# Access Compliance Report

## Public Rights-of-Way (Curb Ramps)

Intersection ID: 2896	Main Street: ALLNESS_GLEN_LN	Cross Street: HARBURN_FOREST_DR	Location: SE
ADA ID: 4F28C2D5221A	Ramp Type: PerpDiag	Initial Pass/Fail: Fail	Overall Compliance: No
Codes/Mitigation Info/Possible Solution		Field Measurements/Component Compliance

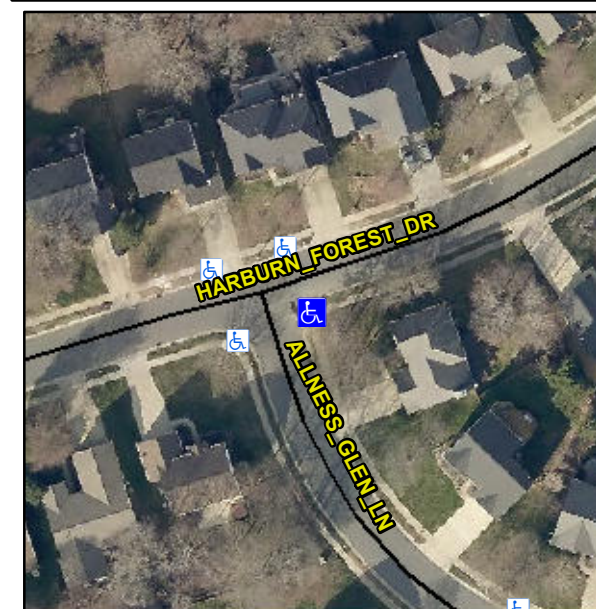
**Not Found, R304.2.2**

Compliance	Description	Data	Compliance	Description	Data
N/A	Ramp Length (in)	48.0	No	Ramp Slope (%)	14.6
Yes	Ramp Width (in)	49.5	Yes	Ramp XSlope (%)	1.1
N/A	Flare Type LT	N/A	N/A	Flare Type RT	N/A
N/A	Flare Slope LT (%)	N/A	N/A	Flare Slope RT (%)	N/A
N/A	Flare Traversable LT?	N/A	N/A	Flare Traversable RT?	N/A
N/A	Landing Length (in)	N/A	N/A	DWS Provided?	N/A
N/A	Landing Width (in)	N/A	N/A	DWS Contrast?	N/A
N/A	Landing Slope (%)	N/A	N/A	DWS Length (in)	N/A
N/A	Landing X Slope (%)	N/A	N/A	DWS Full Width?	N/A
N/A	Landing Curb? (Y/N)	N/A	N/A	DWS Offset (in)	N/A
N/A	Shared Landing?	N/A			
N/A	Gutter Ponding?	Yes	N/A	Gutter Slope (%)	N/A
N/A	Gutter Lip Ht (in)	N/A	N/A	Gutter X Slope (%)	N/A
N/A	Painted X Walk1?	No	N/A	Painted X Walk2?	No
	X Walk 1 Direction	To N		X Walk 2 Direction	To W
N/A	X Walk 1 Width (in)	N/A	N/A	X Walk 2 Width (in)	N/A
	X Walk 1 Slope (%)	3.6		X Walk 2 Slope (%)	1.7
	X Walk 1 X Slope (%)	1.2		X Walk 2 X Slope (%)	0.4

**Remove & Replace Curb Ramp With Two New Directional Ramps or Equivalent.**
